TOWN OF GLASTONBURY
GL-2021-05
GLASTONBURY HIGH SCHOOL ATHLETICS FACILITY
ADDENDUM NO. 2
December 10, 2020

A. RFI Questions and Answers:

C. Drawing Clarifications/ Revisions:

3 ELECTRICAL SITE PLAN
EP-101 1/16" = 1'-0"

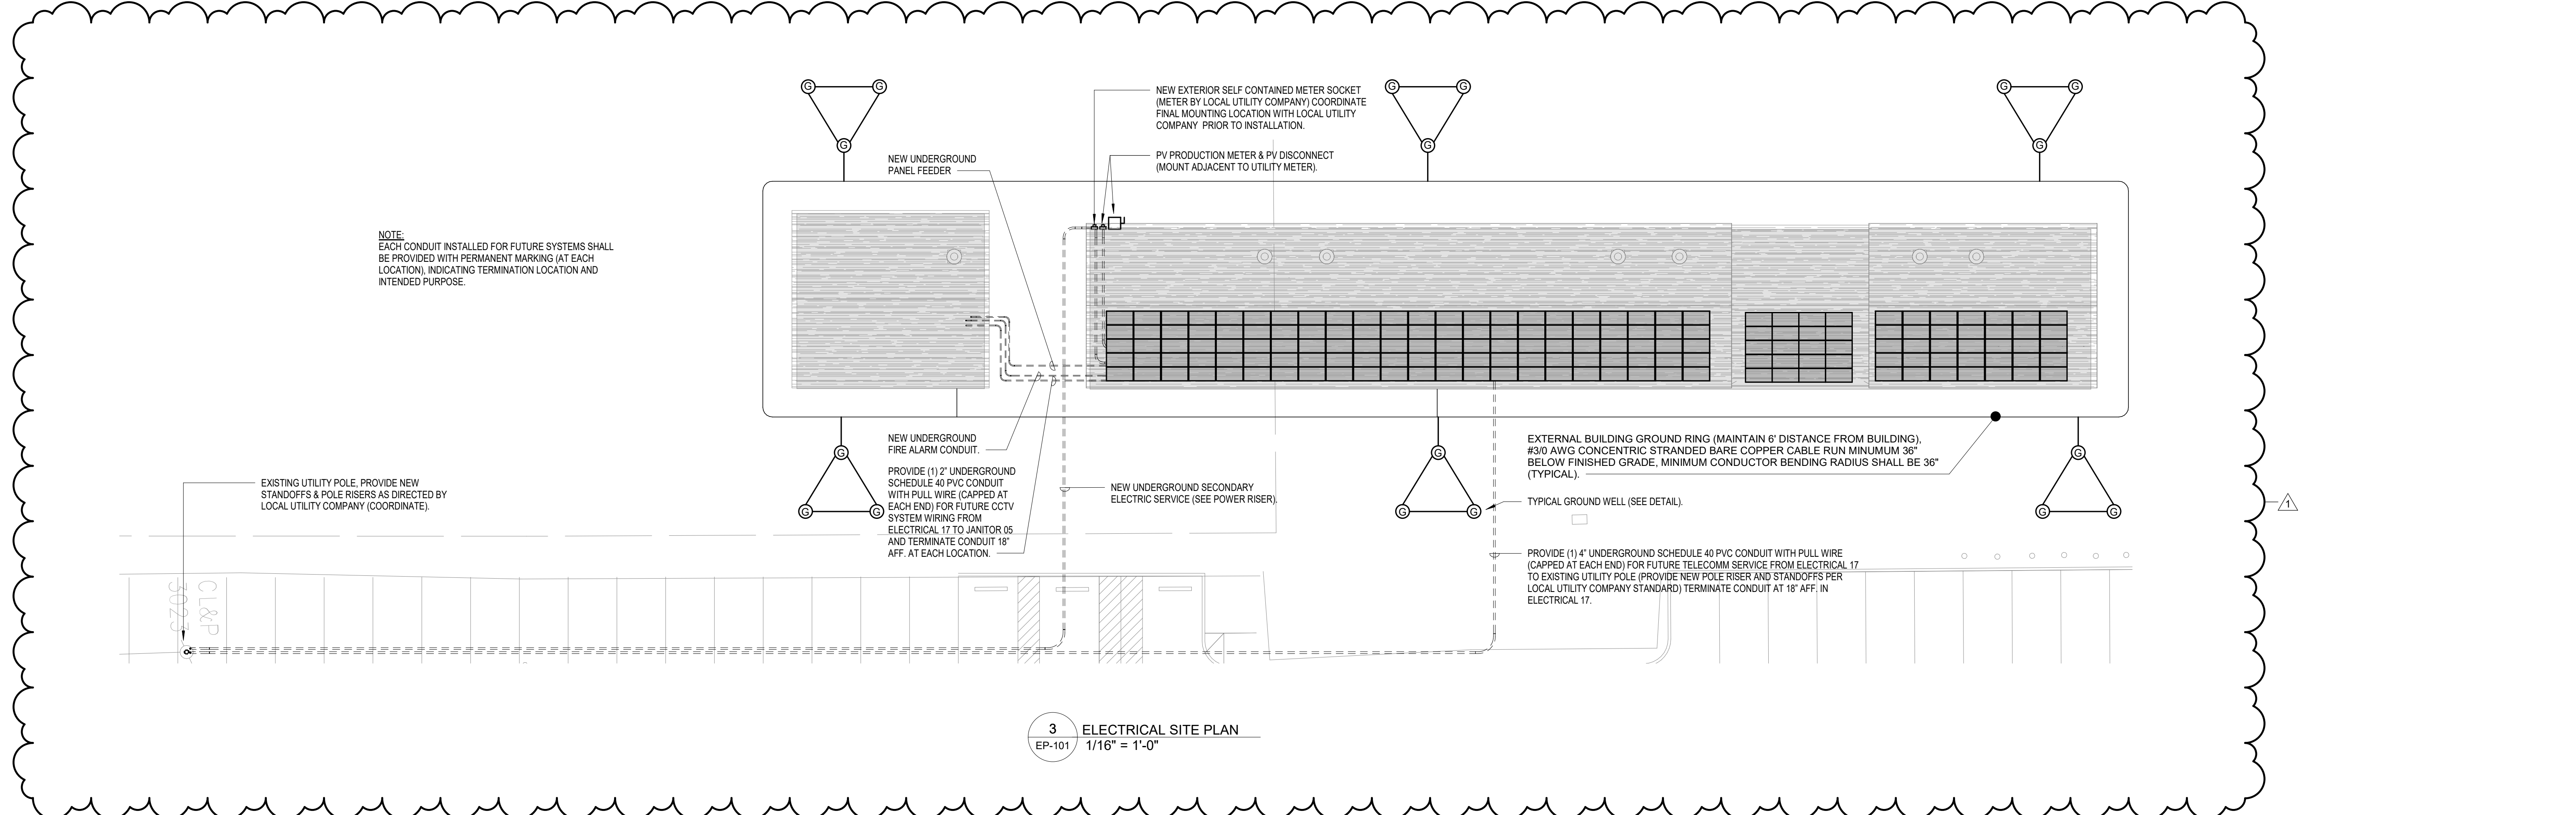
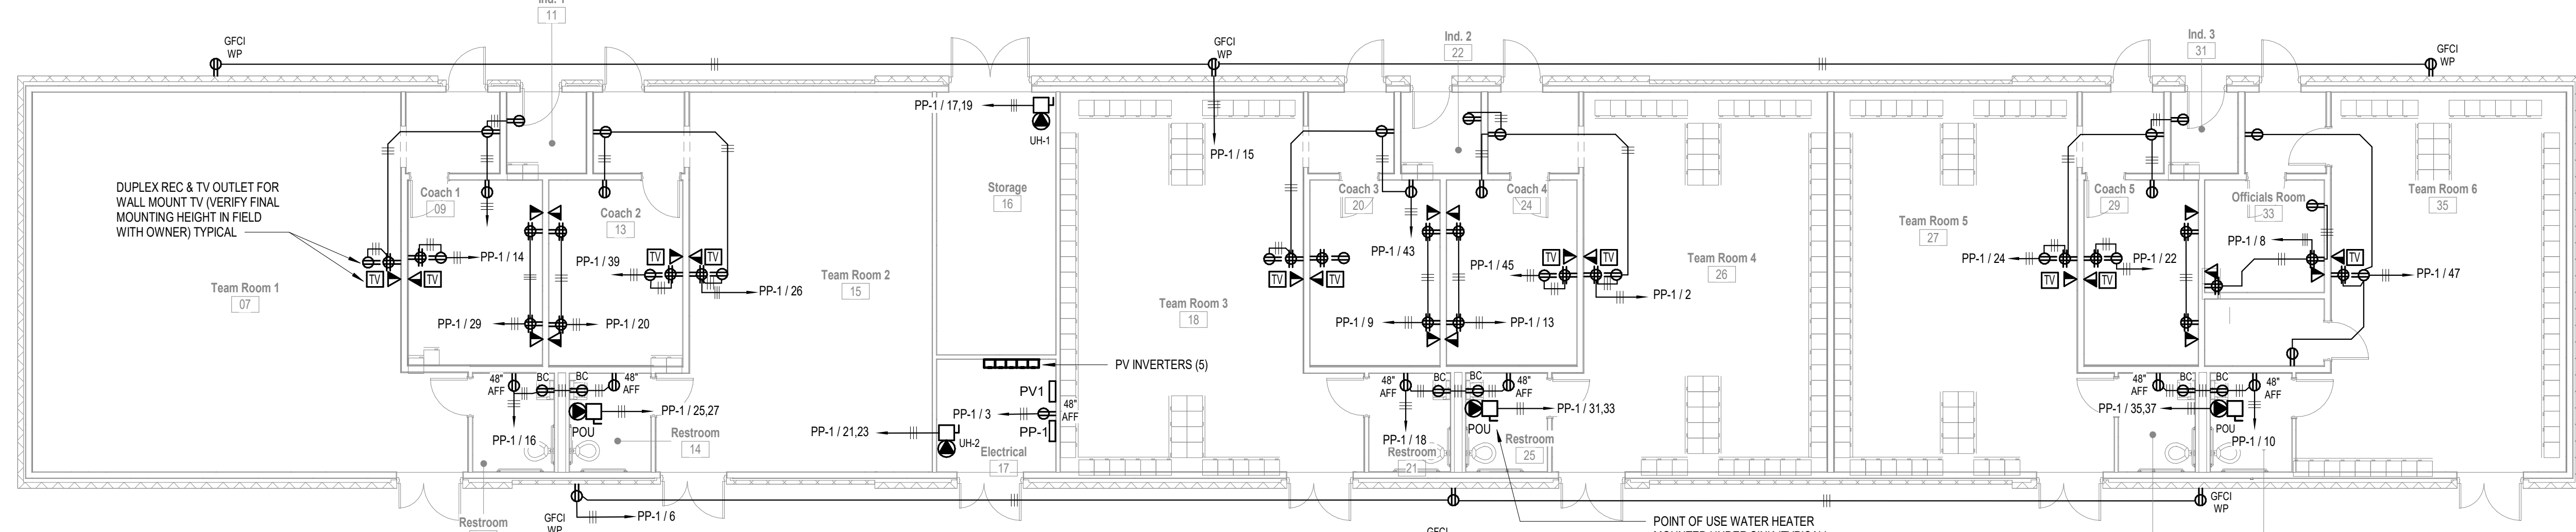
Item #14	EP-101		REPLACED drawing EP-101 with revised drawing dated 12/10/2020
Item #15	EP-101		ADDED Note: Provide (1) 4” underground schedule 40 PVC conduit with pull wire (capped at each end) for future telecomm service from Electrical 17 to existing utility pole (provide new pole riser and standoffs per local utility company standard) terminate conduit at 18” AFF. in Electrical 17.

Item #16	EP-101		ADDED Note: Provided (1) 2” underground schedule 40 PVC conduit with pull wire (capped at each end) for future CCTV system wiring from Electrical 17 to Janitor 05 and terminate conduit 18” AFF. at each location.

NOTE:
EACH CONDUIT INSTALLED FOR FUTURE SYSTEMS SHALL BE PROVIDED WITH PERMANENT MARKING (AT EACH LOCATION), INDICATING TERMINATION LOCATION AND INTENDED PURPOSE.
